TITLE EXCESSIVE OVERSHOOT/SETTLE TIME DELAY REGISTER				PIB NO. DK3025
PRODUCT LINE	TAPE DISK FORMATTER	EQUIPMENT CHANGED All Logic PCBA's	MODEL SERIES AFFECTED D3000	EFFECTIVE DATE 2-14-75
CLASS OF BULLETIN: <input type="checkbox"/> IMPROVEMENT <input checked="" type="checkbox"/> RETROFIT ON FAILURE <input type="checkbox"/> RETROFIT RECOMMENDED <input type="checkbox"/> SERVICE INFORMATION ONLY		ORDER PART KIT NO. N/A	EFFECTIVITY D3000's prior to S/N 1000	
PURPOSE: There have been some isolated cases where a particular D3000 would exhibit excessive overshoot and become one track off. Recent changes may possibly correct this condition on units prior to S/N 1000. UI09, the settle time delay register, can have its time factor shortened. By shorting this settle time, reducing the velocity and leaving the base seek time at approximately 35 milliseconds, the positioner will actually move slower. Results are the present overshoot is cut to a minimum, with no loss in seek performance. Because of the isolated number of instances, "Retrofit on Failure Only".

PIB NO.
DK3025

FIGURE 1

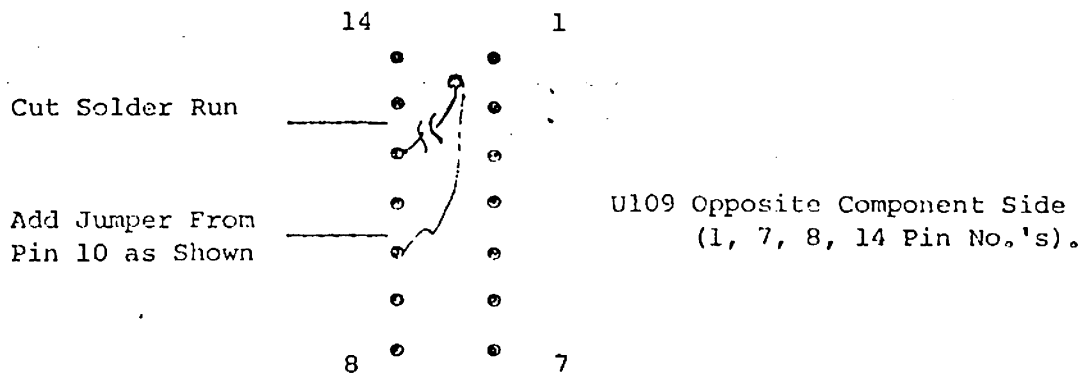
SYMPTOMS: <ul style="list-style-type: none"> - Correct sector but one track off - Addressing errors - Formatter errors - Address compare errors - Unexplainable controller time-outs 				
PARTS REQUIRED: <ul style="list-style-type: none"> - Approximately one (1) inch of jumper wire 30 AWG, silver plated copper wire, Mylar insulation 				
TOOLS REQUIRED: <ul style="list-style-type: none"> - Soldering iron with 25 to 27 watt tip 				
REWORK INSTRUCTIONS: 1.0 Perform all servo adjustments and ensure overshoot is to the minimum. (Ref: D3000 Manual, 102780, Section 6) 2.0 Locate I.C. UI09. (Opposite component side) 2.1 Cut etch to Pin 12 (see Figure 1).

- 2.2 Add jumper from Pin 10 to output etch as shown in Figure 1.
- 2.3 Perform in D3000 Service & Maintenance Manual, Section 6, SEEK TIME FINAL ADJUSTMENTS.

<u>FROM</u>	<u>TO</u>
QG-12	QE-10
